9.16 BCA Report

BCA SIGNIFICANT ISSUES & CONSTRAINTS REPORT

PROPOSED GLOBAL SYDNEY SWITCH 2

REPORT NO ► 1321-15 REV02

Figure 1.0 – Proposed Site, showing two separate buildings

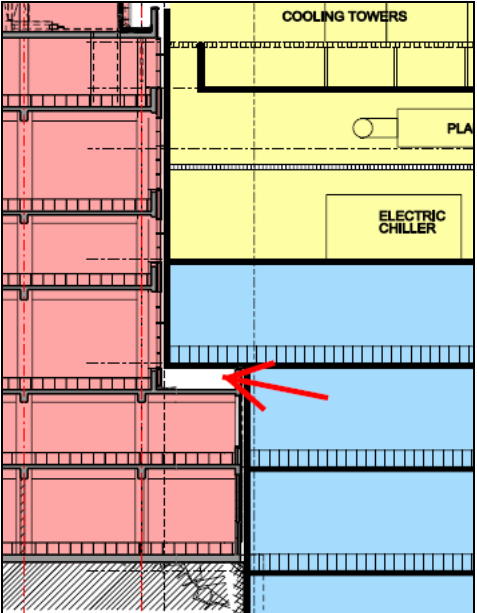
- The Building Code of Australia 2009 (BCA), prepared by the Australian Building Codes Board.
- The Guide to the BCA 2009, prepared by the Australian Building Codes Board.
- The report has been based on both of the sites identified in figure 1.0 above, being a single consolidated allotment of land.

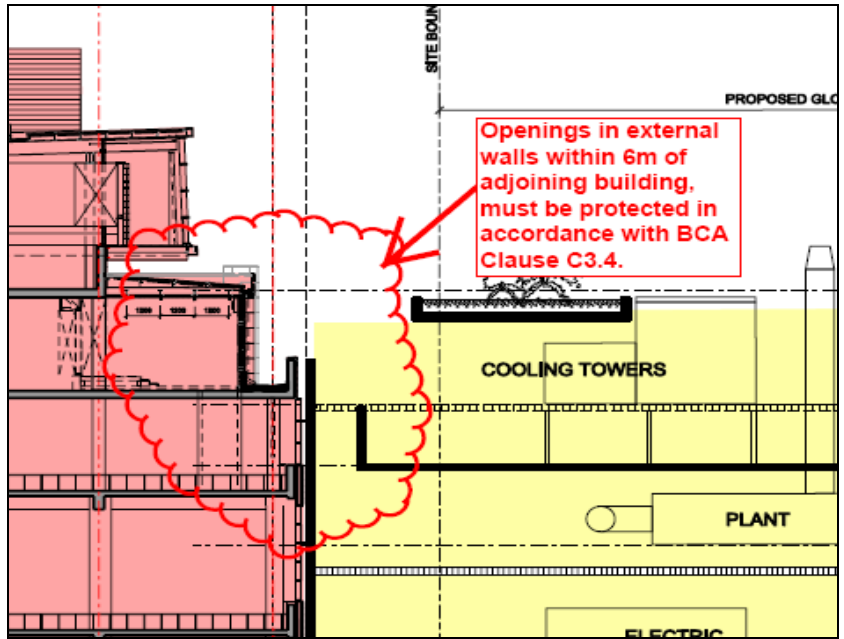
<p>5.</p> <p>Informational and Potential Non-Compliance</p> <p>POTENTIAL ALTERNATIVE SOLUTION REQUIRED</p>	<p>SEPARATION BY FIRE WALLS CLAUSE C2.7 – The fire wall separating the two buildings comprises both vertical and horizontal construction, which does not comply with BCA Clause C2.7(b) which requires that fire walls be provided to separate buildings, ie vertical construction. Refer to diagram below for location of horizontal element that is proposed within the fire wall separating buildings.</p> 
<p>6.</p> <p>Informational</p>	<p>SEPARATION of EQUIPMENT (BCA CLAUSE C2.12 & C2.13) Separation of equipment as listed below must be separated from the remainder of the building by FRL 120/120/120:</p> <ul style="list-style-type: none"> - Boilers; - Lift motors and control panels - Emergency generators used to sustain emergency equipment in the emergency mode; - Central smoke control plant; - Battery stores - Electricity substation and main switch boards (only switchboards used to sustain emergency equipment in the emergency mode)

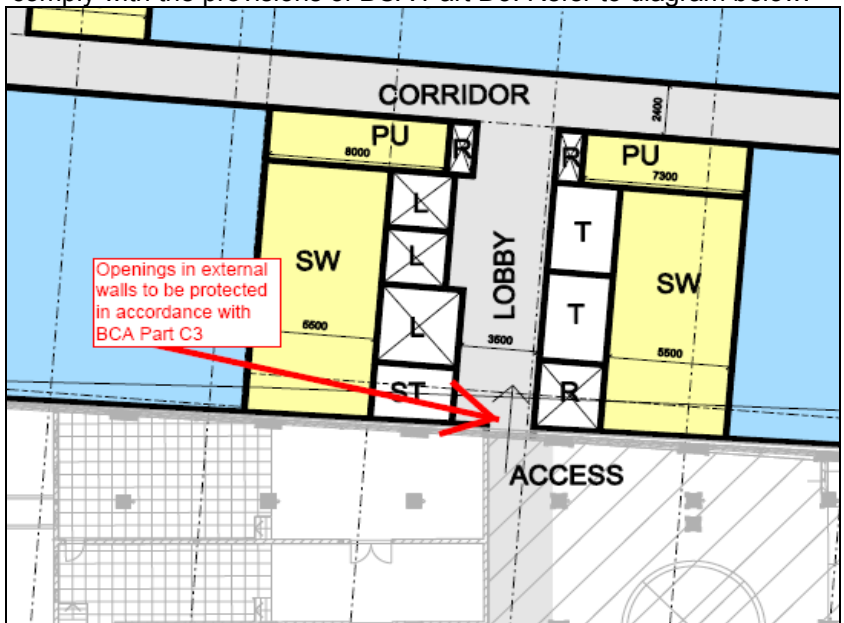
<p>7.</p> <p>Informational and Potential Non-Compliance</p>	<p>PROTECTION OF OPENINGS (BCA CLAUSE C3.2) To comply with BCA Clause C3.2, openings in external walls within 6m of side of the existing building on the same allotment, or 6m of the far side of the road must be protected in accordance with C3.4 of the BCA. Protection of openings to be detailed as the design progresses, however the following openings are specifically noted:</p> <ul style="list-style-type: none"> i. To all openings within 6m of the existing Sydney Global Switch 1 building should be protected. This includes all openings under covered roofs, where the opening is taken to be the line of roof over. Refer to diagram below.
